VALUE ENGINEERING STUDY REPORT

Operations Buildings Poplar Island

Baltimore District US Army Corps of Engineers

17 March 03

A - 01

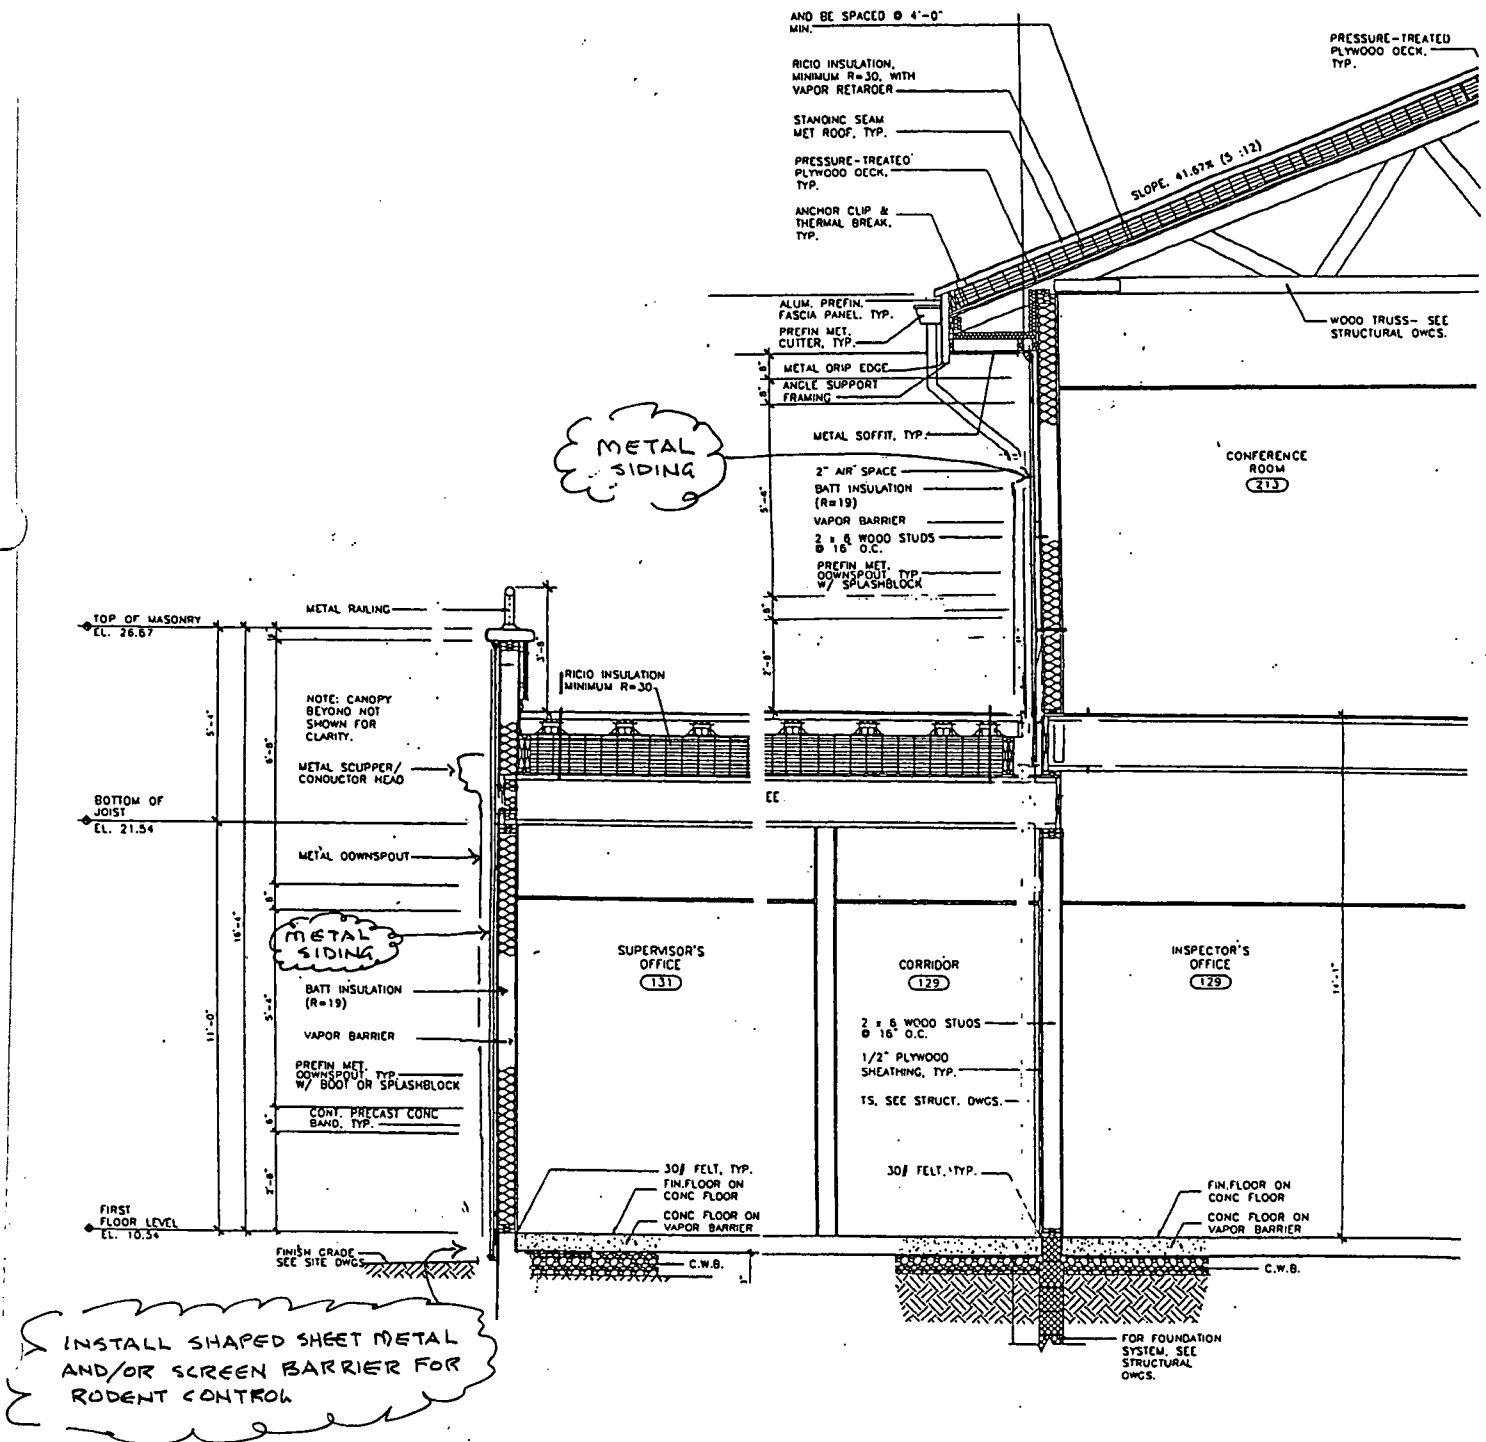
DESCRIPTION: Use pre-fabricated panels in lieu of masonry veneer for the exterior of the Operations Building.

ORIGINAL DESIGN: The exterior of the Operations Building is clad with masonry veneers (brick, split-face block and precast concrete).

PROPOSED DESIGN: Use pre-fabricated metal panels in lieu of masonry veneers. Install shaped sheet metal and screening at base to control rodents.

JUSTIFICATION: The primary purpose for using masonry veneer, as presented during briefings, was to keep rodents (mice) out of the building. The proposed use of pre-fab metal panels with shaped sheet metal/screening at the base will accomplish the rodent control while allowing the benefits listed under "advantages".

A - 02

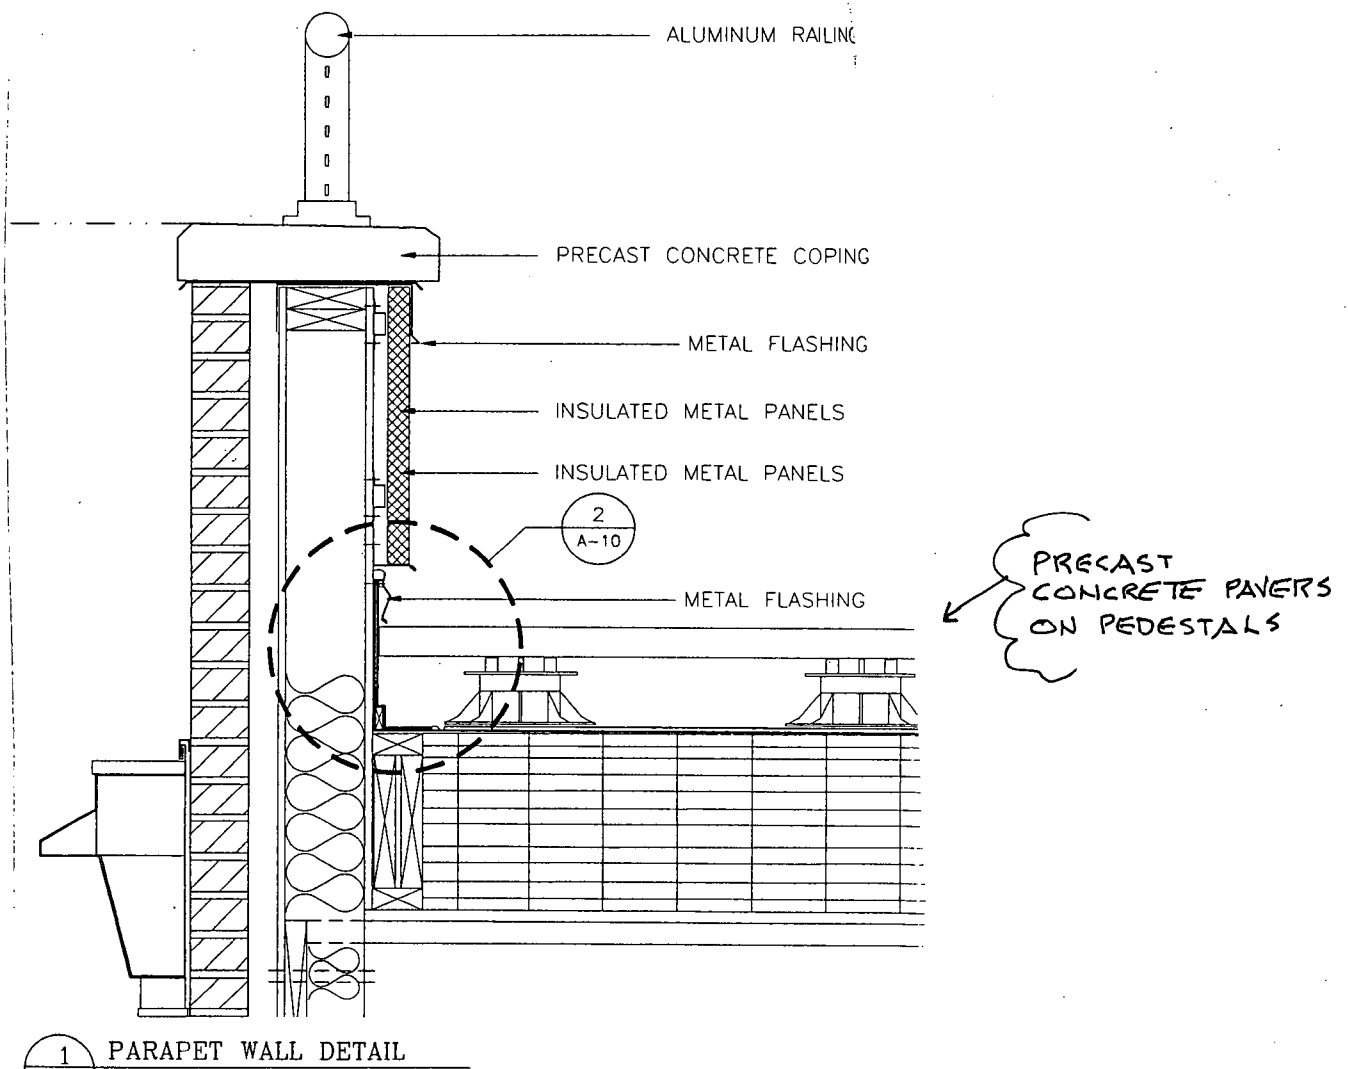
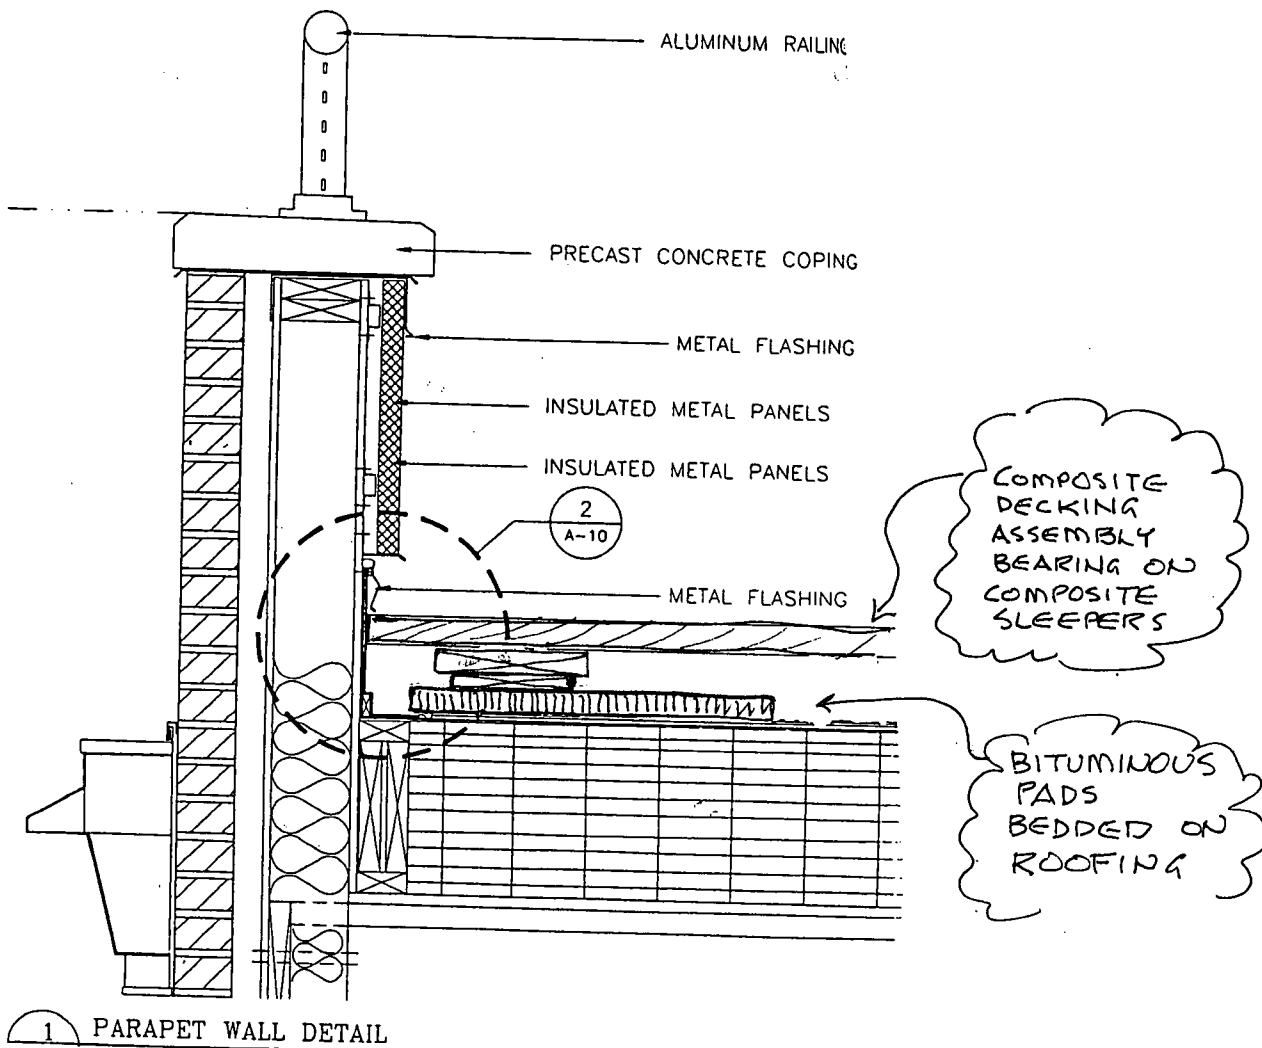
DESCRIPTION: Use composite decking in lieu of precast concrete pavers at the deck of the Operations Building.

ORIGINAL DESIGN: The roof above the lower level of the Operations Building is covered with concrete pavers set on raised pedestals. The pavers allow for observers to walk around the deck surface without damaging the roofing membrane. The pavers are shown as 24" x 24" x 4".

PROPOSED DESIGN: Use composite decking set on composite sleepers that bear on bituminous pads placed on the roofing membrane. The decking may be pre-assembled into pallets so as to reduce the extent of on-site labor.

JUSTIFICATION: The proposed composite decking assembly will serve the same function as the original design concrete pavers. There will be less potential for damage to roofing membrane and less load on the building. The composite material is durable and does not require any finished application.

A - 03

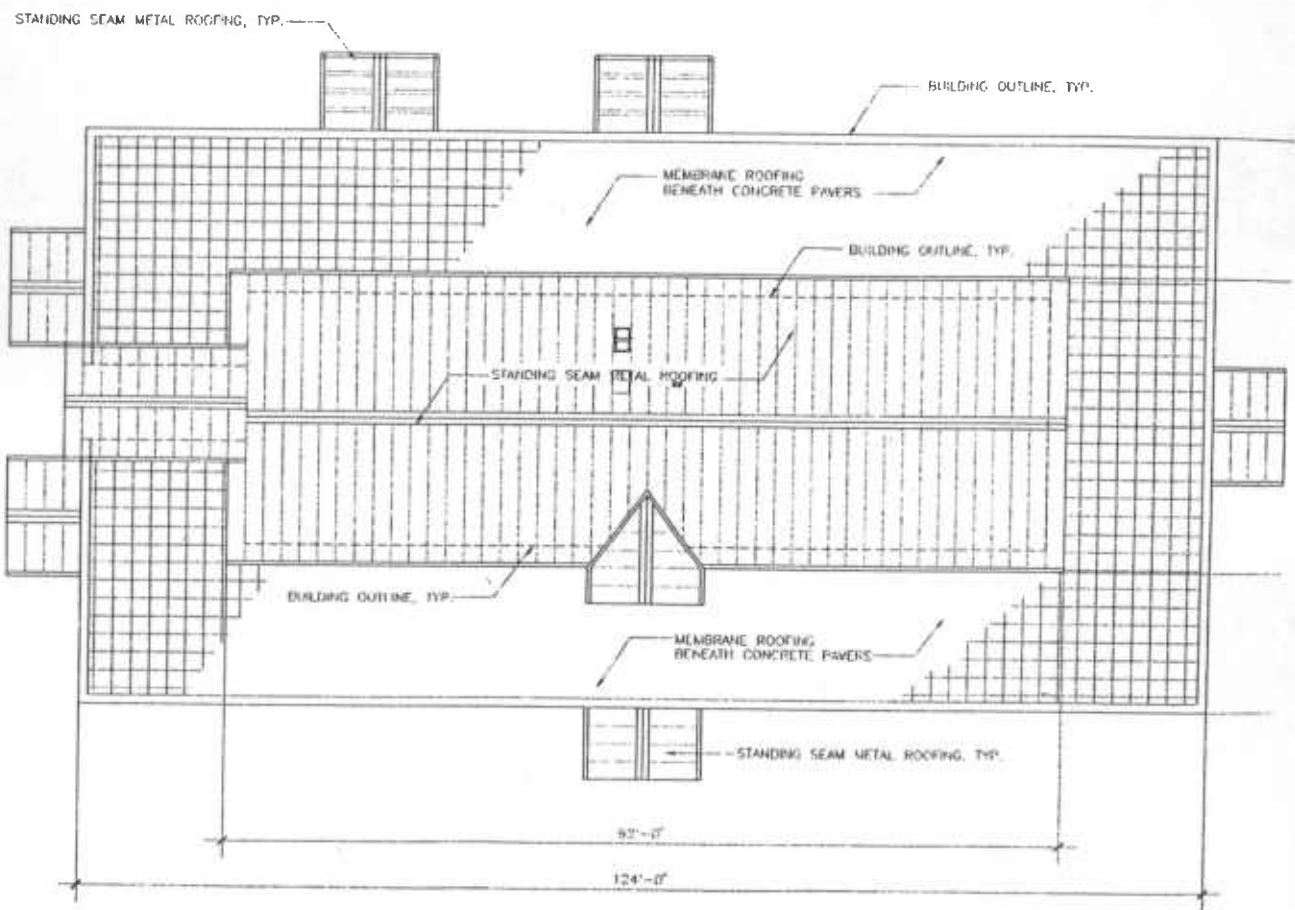
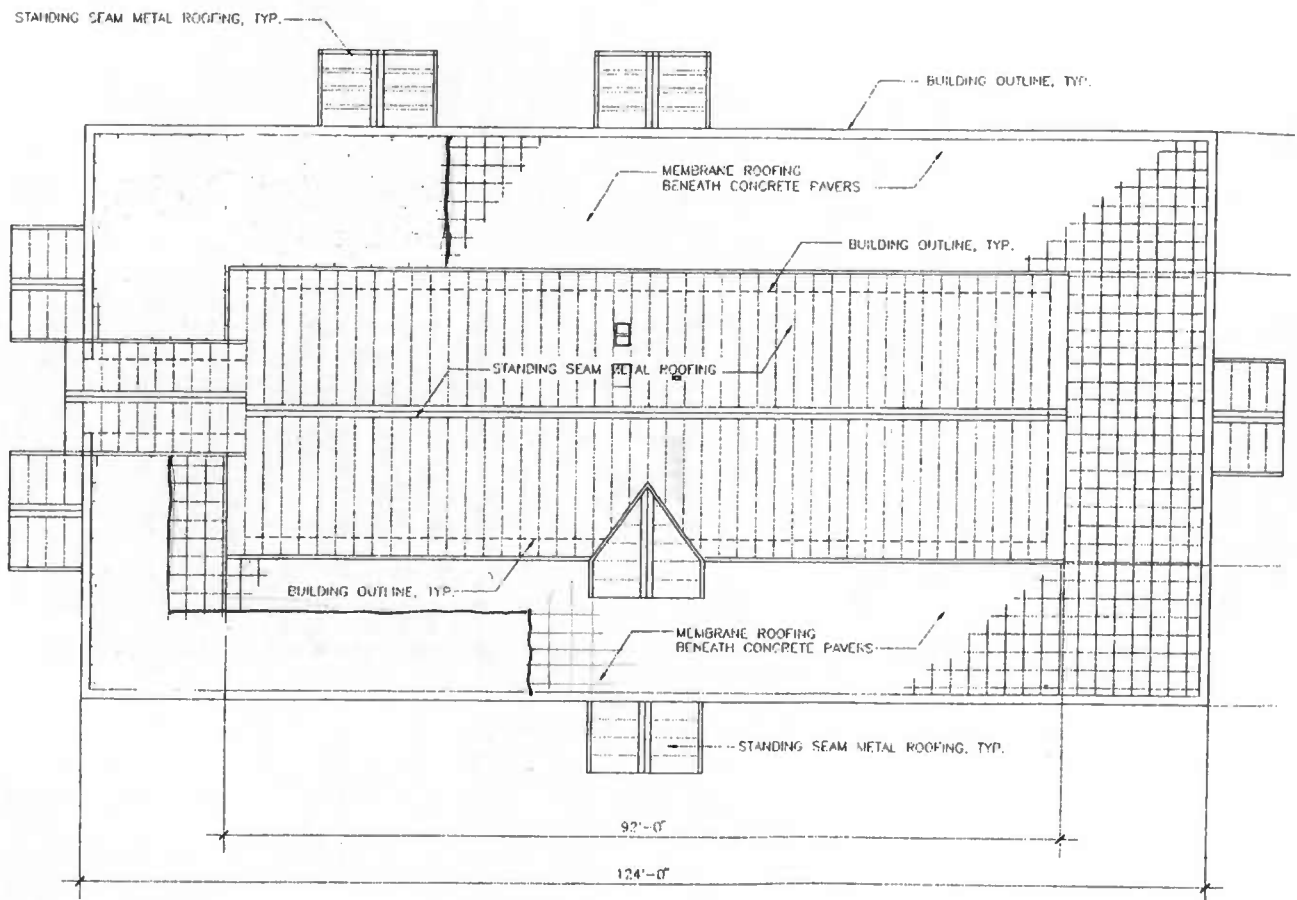
DESCRIPTION: Reduce extent of observation deck area at Operations Building.

ORIGINAL DESIGN: The entire surface of the roof above the lower level of the Operations Building is covered with precast concrete pavers, used as an observation deck.

PROPOSED DESIGN: Reduce extent of observation deck pavers by omitting pavers from those areas where viewing is not involved.

JUSTIFICATION: Views from the roof top are restricted in some directions due to topography and/or interference caused by the storage/maintenance buildings. In some areas, the exhaust from toilets, kitchen, and fume hood may interfere with public access. Accordingly, segments of the roof area will not serve as an observation space. Pavers at those areas may be omitted except for the extent required for circulation. (Exact location of omitted areas to be determined by users.)
